**Product/Process Change Notification(产品或过程变更通知)**

Amphenol P/N 安费诺料号	12402032E202A 12402069E202A	Customer P/N 客户料号		Product Description 产品描述	USB 3.1 GEN1, Type C connector, vertical Double SMT type, L=6.50mm
-----------------------	--------------------------------	----------------------	--	-----------------------------	---

Change Description 变更描述	After change applied变更后应用	Before change applied变更前应用

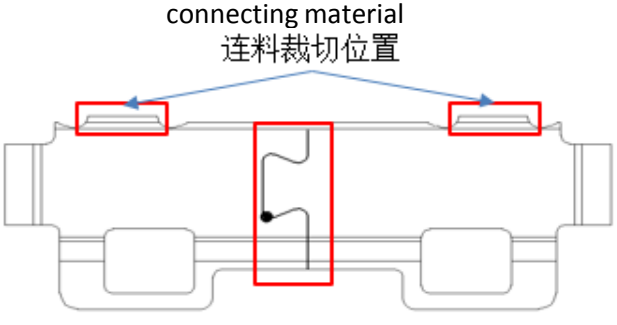
<p><b>EMC改为冲压拉伸壳方式</b></p> <p>1.没有折弯壳的结合线及连料裁切 可避免结合线裂开及连料裁切位置翘起</p> <p>2.取消100%用1.20治具全检, 提高生产效率</p> <p>EMC changed to stamping - Tensile shell mode</p> <p>1. No bending shell well line and connecting material cutting avoid well line split and connecting material cutting position warped</p> <p>2. Cancel the full inspection of 100% 1.20 fixture to improve production efficiency</p>	<p><b>EMC为冲压折弯壳方式</b></p> <p>1.组装后易造成结合线裂开, 导致1.20尺寸不稳定</p> <p>2.连料位置需要裁切后组装 裁切易造成连料位置翘起, 配插有插不到底风险 (当前100%用1.20治具全检)</p> <p>EMC is stamping - bending shell mode</p> <p>1. After assembly, it is easy to cause cracking of the well line, resulting in unstable size of 1.20</p> <p>2. The connecting position needs to be cut and assembled Cutting is easy to cause the position of the material to become warped, and there is a risk of not inserting in the end ( 100% fully checked with 1.20 fixture)</p>
